RE: RESPONSE TO REQUEST FOR FURTHER INFORMATION IN RELATON TO DA2018/1574 FOR A PROPOSED DEVELOPMENT AT 23 FISHER ROAD, DEE WHY

This document provides a response on behalf of Hamptons By Rose Pty Ltd (Rose Group) in relation to matters raised by Council in its 'Request for Further Information' issued 17 January 2019, relating to DA2018/1574.

Figures above: Internal and External modifications to the north-west corner proposed following RFI received

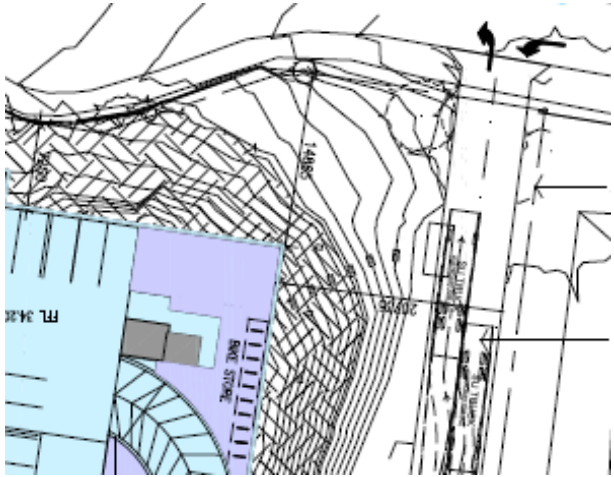
Council Correspondence	Applicant Response
<p>The geotechnical risk management report suggests ongoing dewatering of the basement; yet no information is provided in this regard. It is Council's preference for the basement to be tanked in accordance with the Sydney Coastal Council's "Groundwater Management Handbook – A Guide for Local Government" to avoid the need to continually pump out groundwater. The geotechnical report and stormwater management plans are to be amended in this regard.</p>	<p>not required, and the application has been submitted in accordance with the Regulations.</p>
<p>4. Height, Bulk and Scale</p> <p>D9 (Building Bulk) of WDCP</p> <p>Concern is raised in relation to the visual impact of the north-west corner of the development as seen from Fisher Road (demonstrated by 'View 2 – Fisher Road' in the photomontages provided to support the application). The proposed 7-storey presentation to Fisher Road is at odds with the surrounding scale of development, specifically the low-density residential character of development on the western side of Fisher Road.</p> <p>The 7-storey presentation is directly attributed to an excessive level of excavation and disturbance of natural rock outcrops, inconsistent with the requirements and objectives of clause D9 of WDCP. Furthermore, a portion of the 7-storey presentation protrudes beyond the 13m maximum height development standard, which is considered to be unacceptable given the extent of site disturbance.</p> <p>The proposal should be amended to retain the natural rock formations presenting to Fisher Road in the north-west corner of the site, with a more natural landscaped solution presenting to the public domain. Furthermore, the upper floor of the development is to be setback (compliant with the height limit), to minimise the apparent size of the development as seen from the adjacent low-density area.</p>	<p>The building frontage to Fisher Road has been amended to delete one of the dwellings facing the internal driveway (Apartment A.LG1), in order to ensure an appropriate bulk and scale of the development at the north-west corner, and to deliver a high standard of landscaping. This is shown in the floor plan extract below and CGI image provided in the Architectural plans in Appendix 1. Both demonstrate a significantly reduced building footprint in the north western corner and an improved response to the streetscape.</p>

This modification will significantly soften the north-west corner's appearance by enabling the retention of some of the natural rock formations presenting to Fisher Road, which presents as a more natural landscaped solution.
